Access Compliance Report

Public Rights-of-Way

Intersection ID: 15710	Main Street: DONNEFIELD_DR	Cross Street: LAWYERS_RD	Location: SW
ADA ID: AB9377CFF9D4	Ramp Type: PerpDiag	Initial Pass/Fail: Fail	Overall Compliance: No
		Severity Score: 22.5

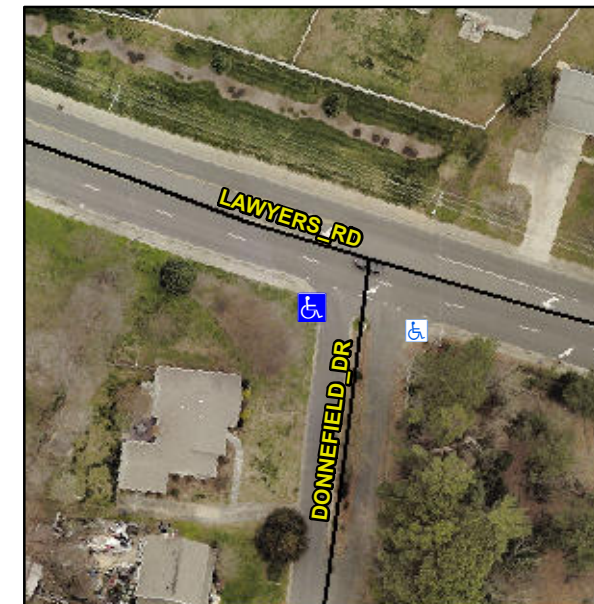
Not Found, R304.5.1, R304.2.2, R304.5.3

Compliance	Description	Data	Compliance	Description	Data
N/A	Ramp Length (in)	60.0	No	Ramp Slope (%)	10.9
No	Ramp Width (in)	43.0	No	Ramp XSlope (%)	4.1
N/A	Flare Type LT	N/A	N/A	Flare Type RT	N/A
N/A	Flare Slope LT (%)	N/A	N/A	Flare Slope RT (%)	N/A
N/A	Flare Traversable LT?	N/A	N/A	Flare Traversable RT?	N/A
N/A	Landing Length (in)	N/A	N/A	DWS Provided?	N/A
N/A	Landing Width (in)	N/A	N/A	DWS Contrast?	N/A
N/A	Landing Slope (%)	N/A	N/A	DWS Length (in)	N/A
N/A	Landing X Slope (%)	N/A	N/A	DWS Full Width?	N/A
N/A	Landing Curb? (Y/N)	N/A	N/A	DWS Offset (in)	N/A
N/A	Shared Landing?	N/A			
N/A	Gutter Ponding?	N/A	N/A	Gutter Slope (%)	N/A
N/A	Gutter Lip Ht (in)	N/A	N/A	Gutter X Slope (%)	N/A
N/A	Painted X Walk1?	No	N/A	Painted X Walk2?	No
	X Walk 1 Direction	To SE		X Walk 2 Direction	To NE
N/A	X Walk 1 Width (in)	N/A	N/A	X Walk 2 Width (in)	N/A
	X Walk 1 Slope (%)	5.7		X Walk 2 Slope (%)	4.7
	X Walk 1 X Slope (%)	4.4		X Walk 2 X Slope (%)	4.5

Remove & Replace Curb Ramp With Two New Directional Ramps or Equivalent.
